## AIR CONDITIONING COOLING IS INSUFFICIENT

This Service Information Bulletin (Revision 1) replaces SI B64 06 17 **dated November 2017**.

**CORRECTION**

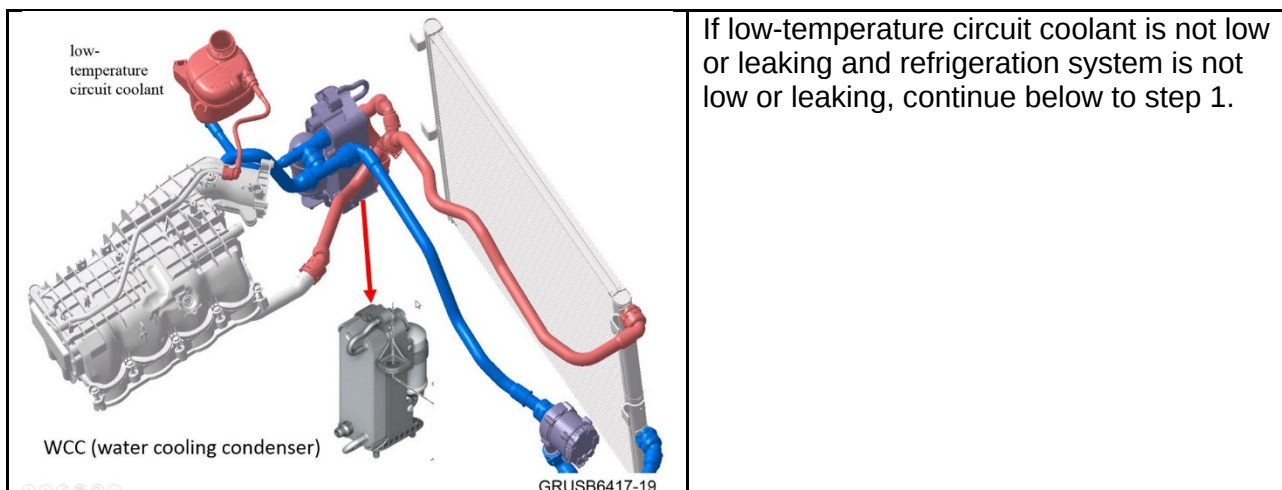
Gel formation and obstruction in the coolant circuit is caused by a reaction between the engine coolant fluid and flux residue from the WCC (Water-Cooled Condenser).

After elimination of other possibilities, replace:

- Low-temperature radiator
- Intake system with charge air cooler
- Water Cooling Condenser (WCC)
- Renew coolant fluid (Anti-freeze)
